ORIGINATION FORM

Proposed Revisions to a Standard Plans Index

Index Number: 455-054
Sheet Number (s): 1
Index Title: 54" Precast/Post-Tensioned Concrete
Cylinder Pile

ELEVATION

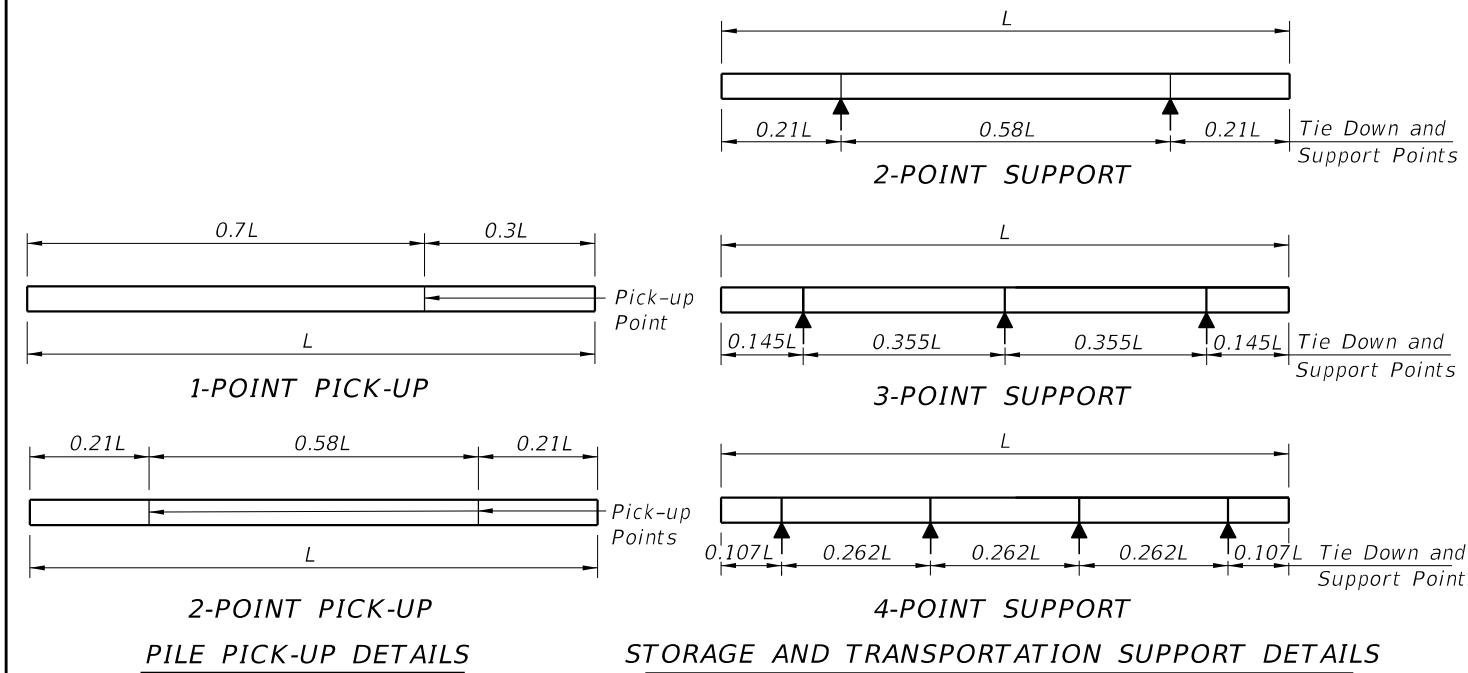
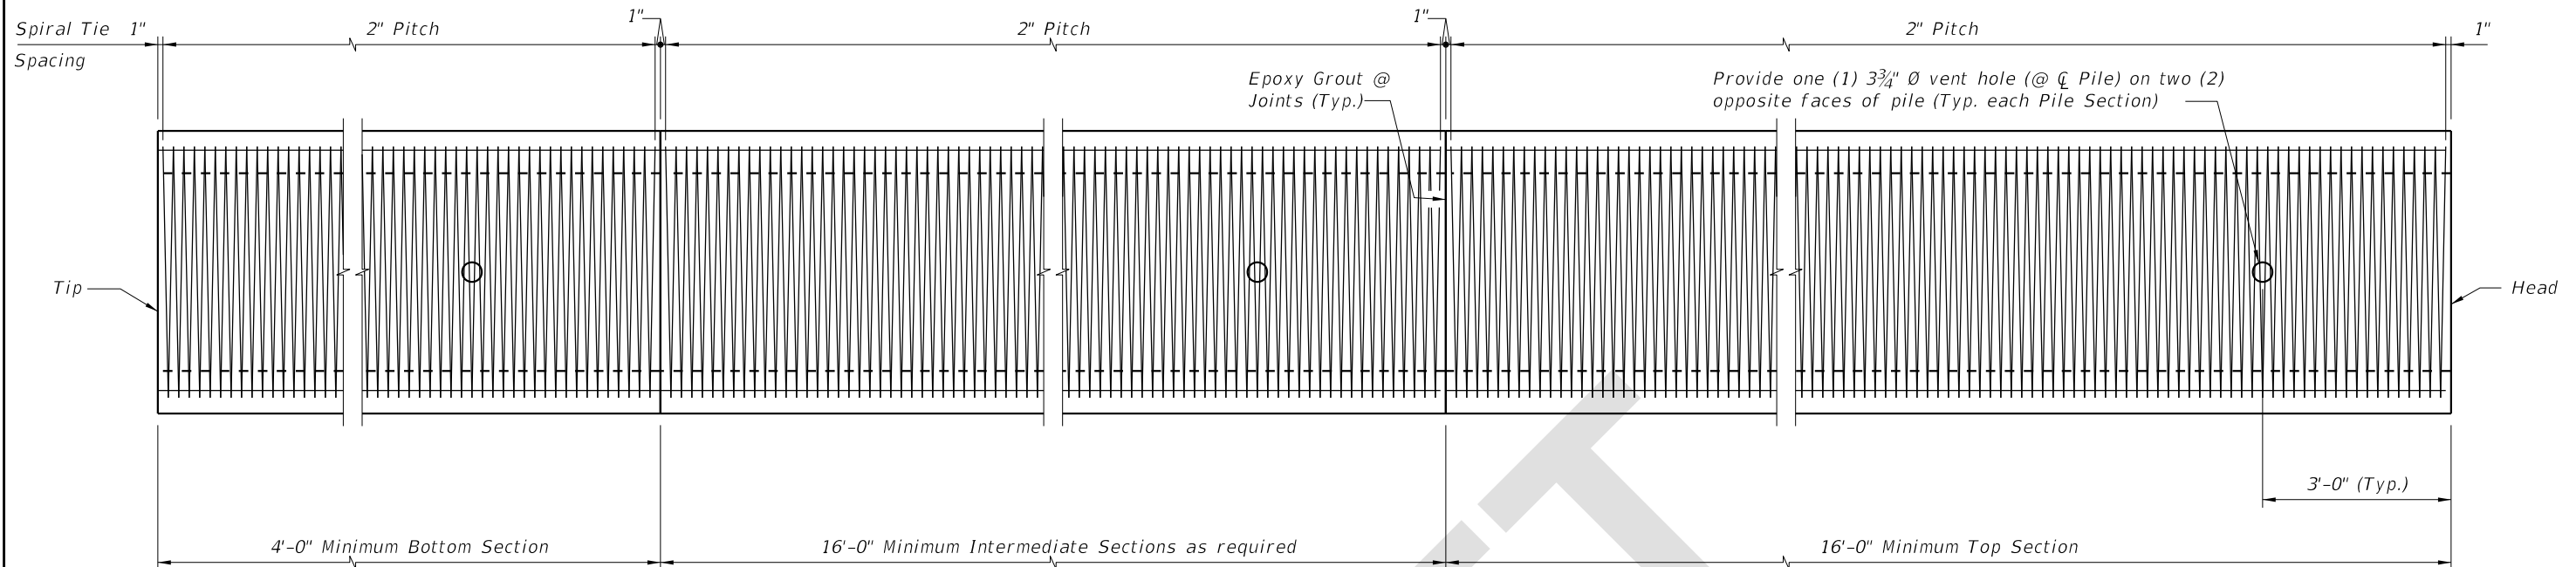
Changed Class V (Special) concrete to Class V.

- NOTES**
- Work this Index with the Pile Data Table in the Structures Plans.
 - Concrete:
 - Piles: Class V ~~(Special)~~
 - Splice: Class IV.
 - See "GENERAL NOTES" in Structures Plans for locations where the use of Highly Reactive Pozzolans is required.
